AUSTIN FIRE DEPARTMENT

2024 International Wildland Urban Interface
Code Adoption

Local Amendment
Adoption

2024 Proposed WUI Map

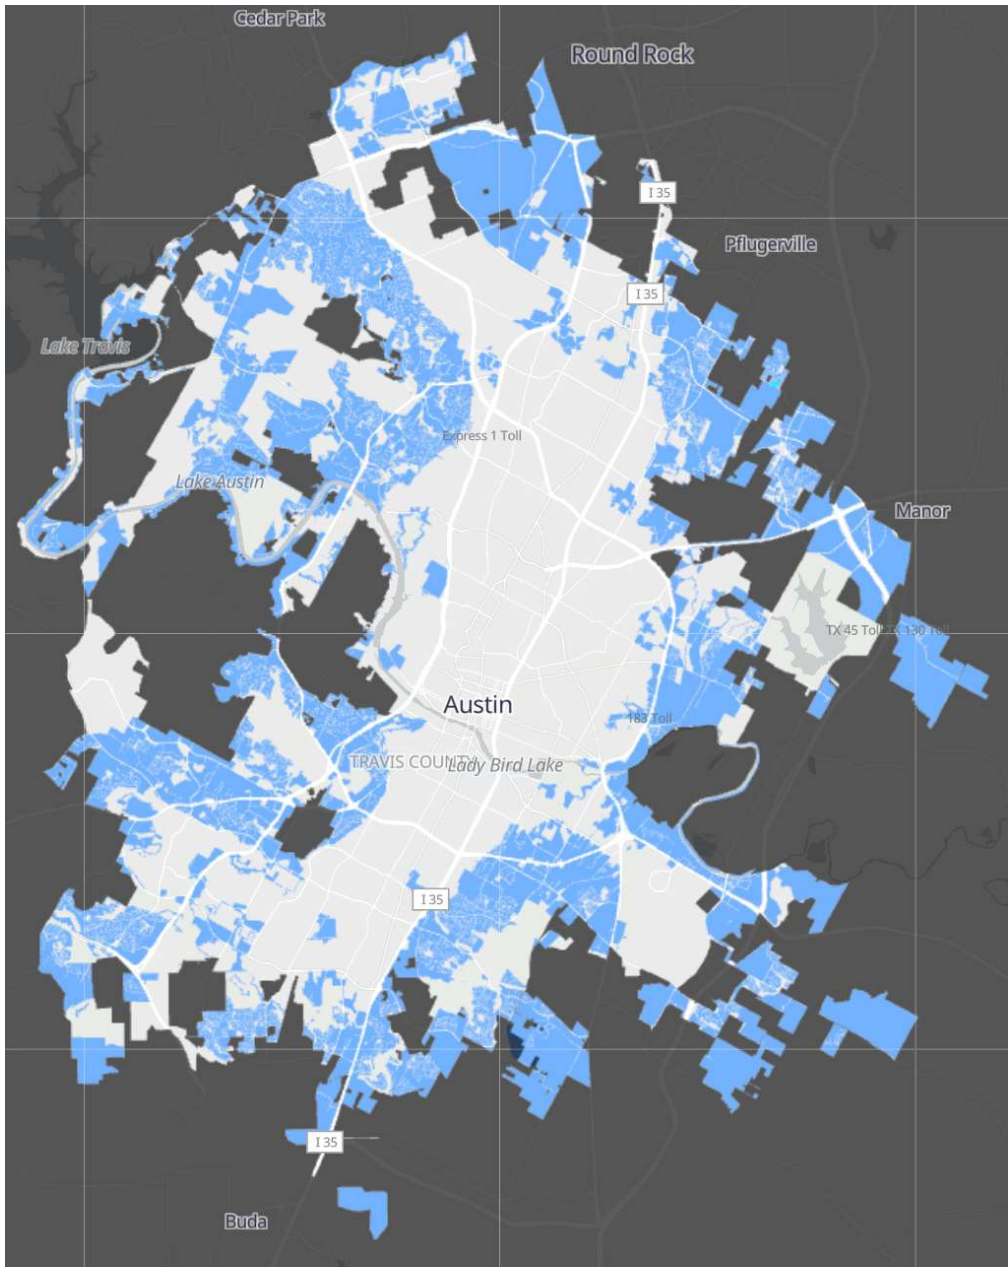
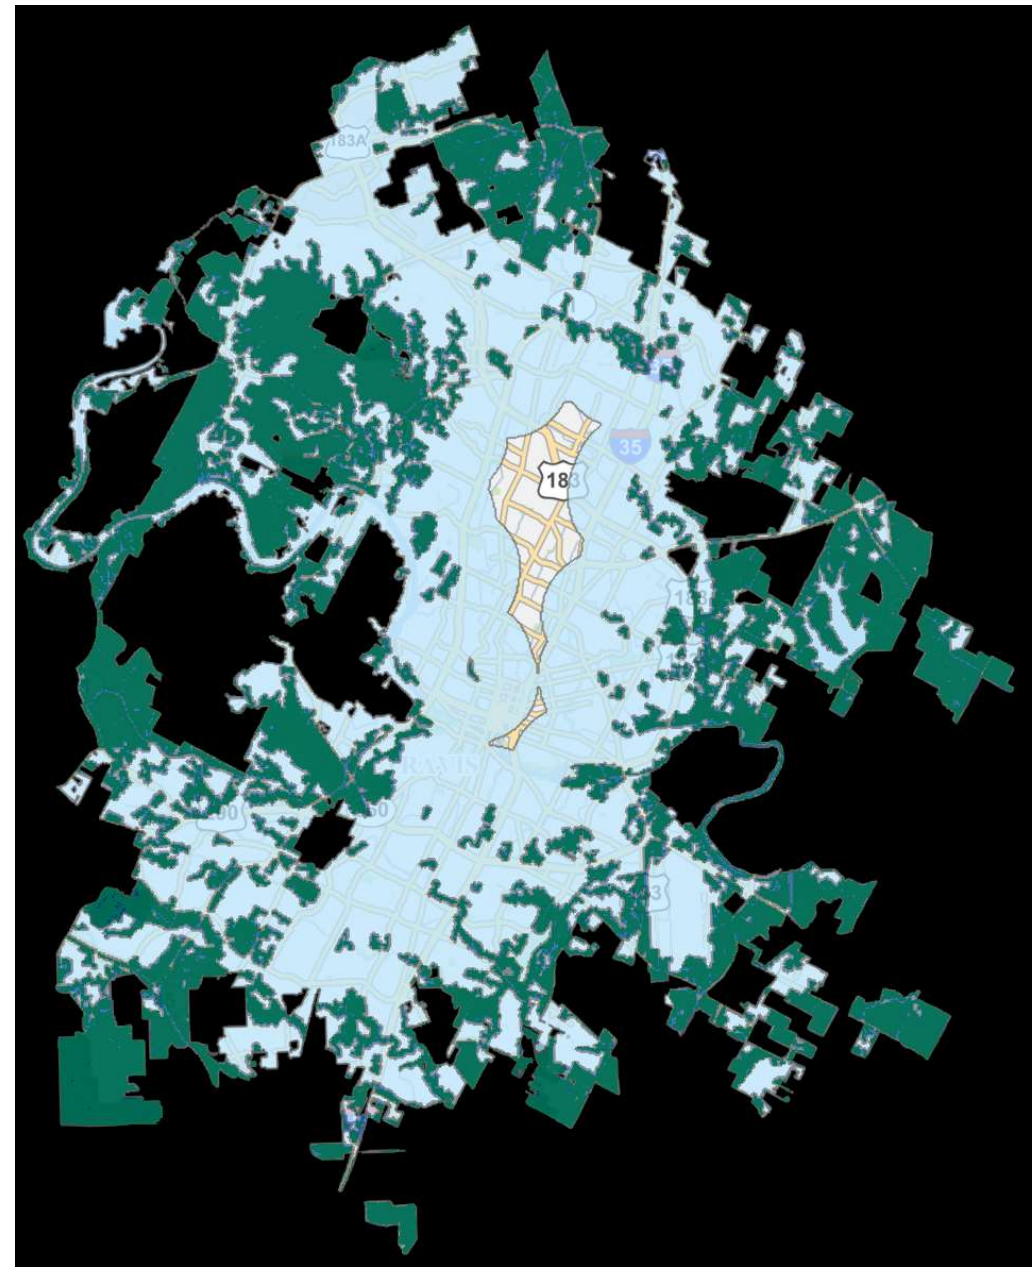
Proximity Zones:

Zone A: Within 50' of 10 acre+ wildland

Zone B: Within 150' of 10 acre+ wildland

Zone C: Within 1.5 miles of 10 acre+ wildland

WUI Map Option B - Overlay on Wildfire Risk Map

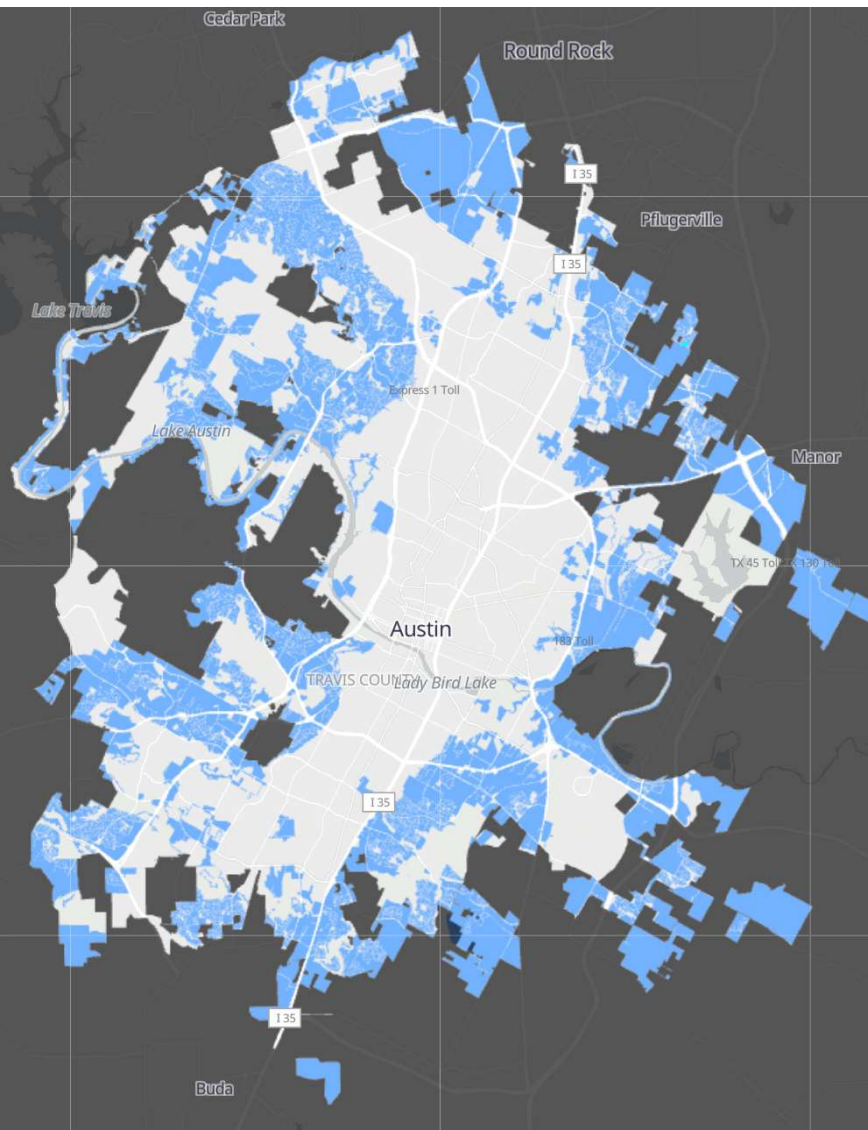
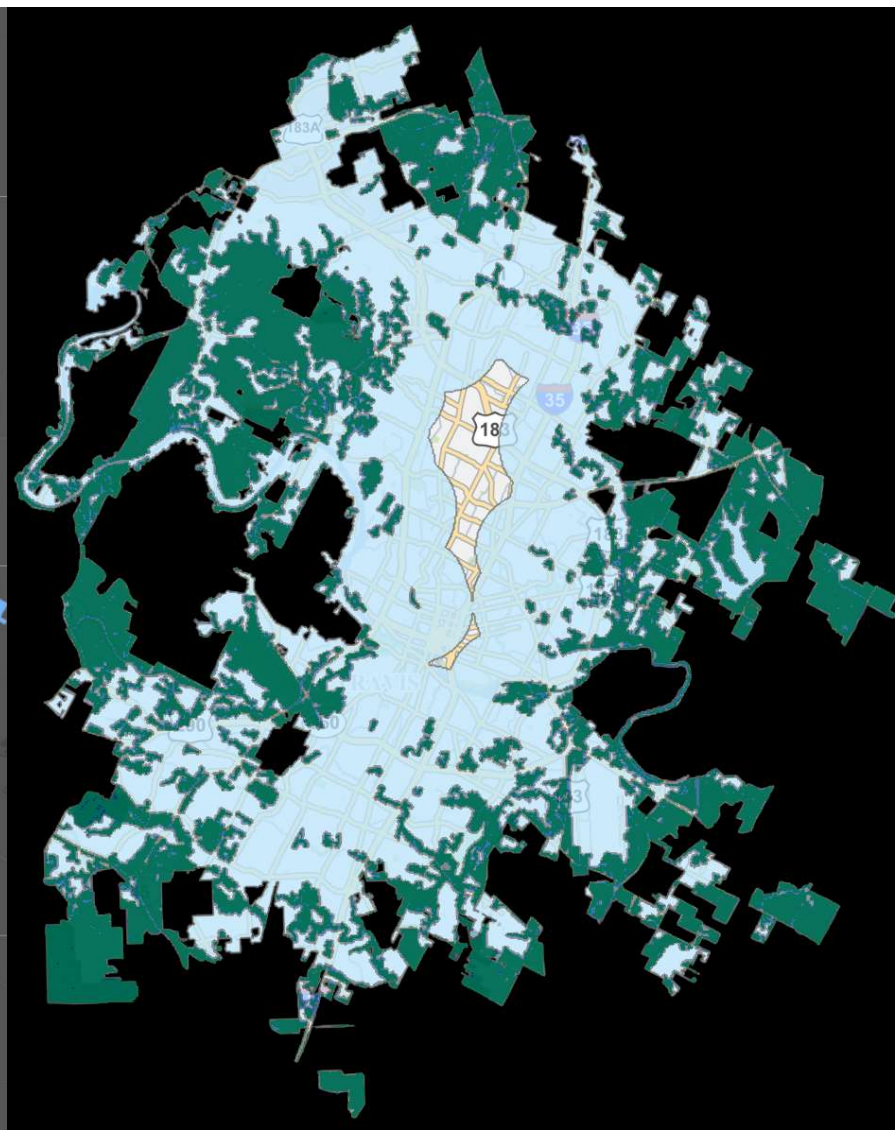
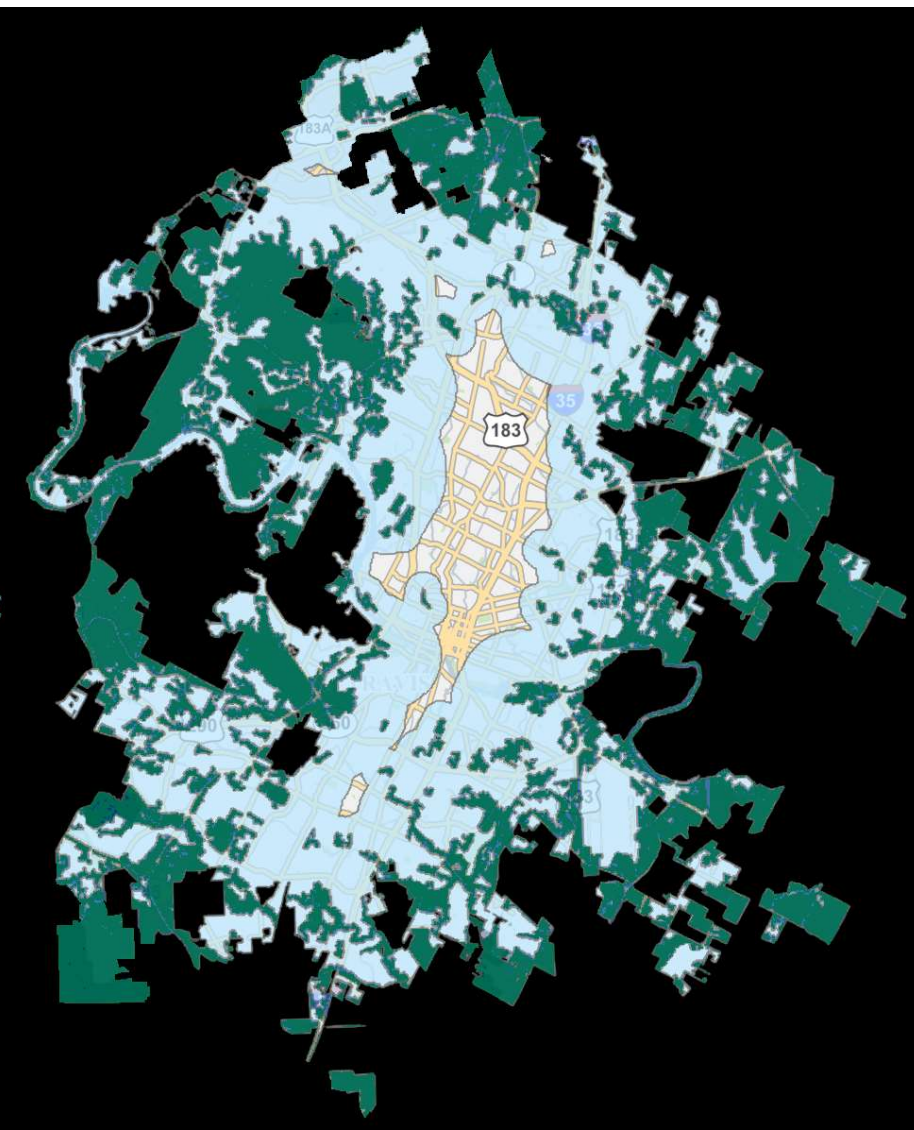
Wildland, Proximity Zones A & B -
150 feet from all wildland 10 acres or greater

Proximity Zone C -

- 0.5 miles from all wildland 10 acres+*
- 1.5 miles from wildland 100 acre+*
